Well Name: SOSA FEDERAL	Well Location: T26S / R29E / SEC 15 / SWSE / 32.0357847 / -103.9685559	County or Parish/State: EDDY / NM
Well Number: 1	Type of Well: OIL WELL	Allottee or Tribe Name:
Lease Number: NMNM44532	Unit or CA Name:	Unit or CA Number:
US Well Number: 3001526087	Operator: COG OPERATING LLC

Notice of Intent

Type of Submission: Notice of Intent	Type of Action: Plug and Abandonment
Date Sundry Submitted: 01/21/2025	Time Sundry Submitted: 01:41
Date proposed operation will begin: 01/21/2025

**Proposed P&A NOI**  
**COG Operating, LLC**  
**Sosa Federal #1**  
**30-015-26087**

<b>ConocoPhillips</b>		<b>PROPOSED</b>	
Author:	Abby @ JMR	Well No.	1
Well Name	Sosa Federal	API #:	30-015-26087
Field/Pool	Brushy Draw Delaware	Location:	Sec 15 T26S, R29E,
County	Eddy		330'FSL & 1700'FEL
State	NM	GL:	2924'
Spud Date	5/8/1989

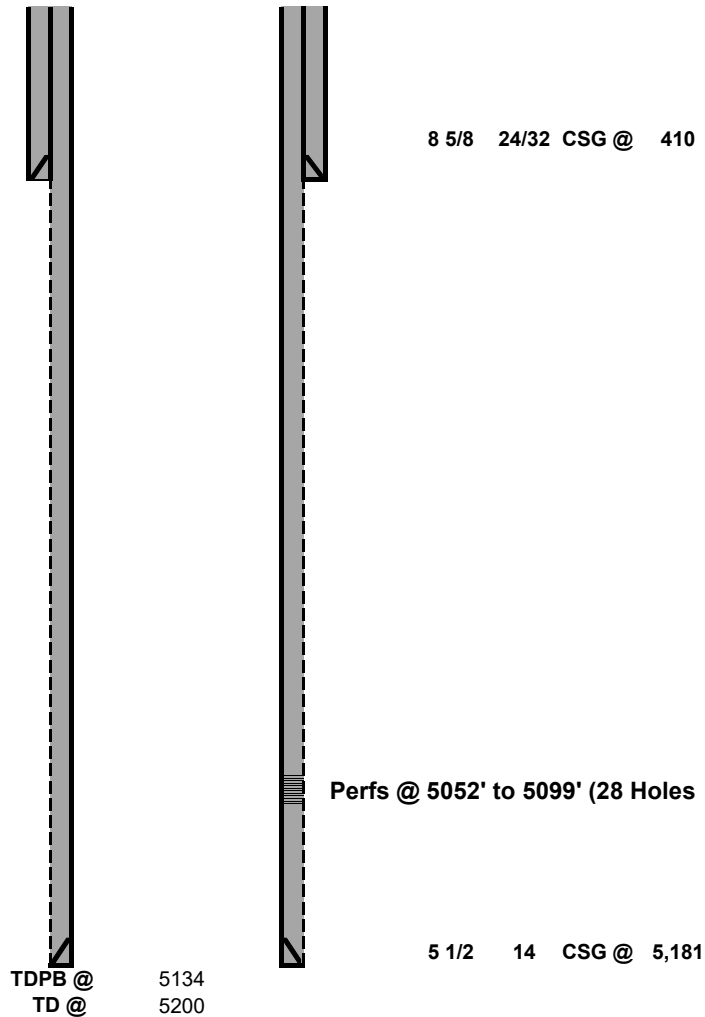
10. Plug #2: Cherry formation top: Spot 25 sx cement from 3,840 to 3,650.
11. Plug #3: B/Salt & Lamar formation top: Spot ~~37~~ sx cement w/ CaCl from 3,000 to ~~2,700~~. WOC & tag. If tag is lower than ~~2,700~~, discuss ~~42 sxs, 3000' to 2681'~~.  
with with representatives for procedure change.
12. Plug #4: Salado, T/Salt, & Rustler formation tops & 8 5/8 shoe: Spot ~~82~~ sx cement w/ CaCl from 740 to surface. ~~98 sxs~~
13. RD cementing equipment. Cut off wellhead, fill any exposed annulus with cement, as necessary. Install DHM.
14. Record GPS coordinates for P&A marker and the Final P&A Report. Photograph the P&A marker and attach to the report.
15. RDMO all rig and cement equipment. Assure that location is free of trash before moving off.
16. Send all reports and attachments will be uploaded to NMOCD website within 30 days of completion.

Plug #3: Spot 42 sx class C cmt w/ CaCl @ 3000-2681'. WOC & tag. (B/Salt & Lamar)

11. Plug #3: B/Salt & Lamar formation top: Spot 42 sx cement w/ CaCl from 3,000' to 2681'. WOC & tag. If tag is lower than 2681', discuss with with representatives for procedure change.

Plug #4: Spot 98 sx class C cmt w/ CaCl @ 740' to surface. (Salado, T/Salt, 8 5/8" shoe)
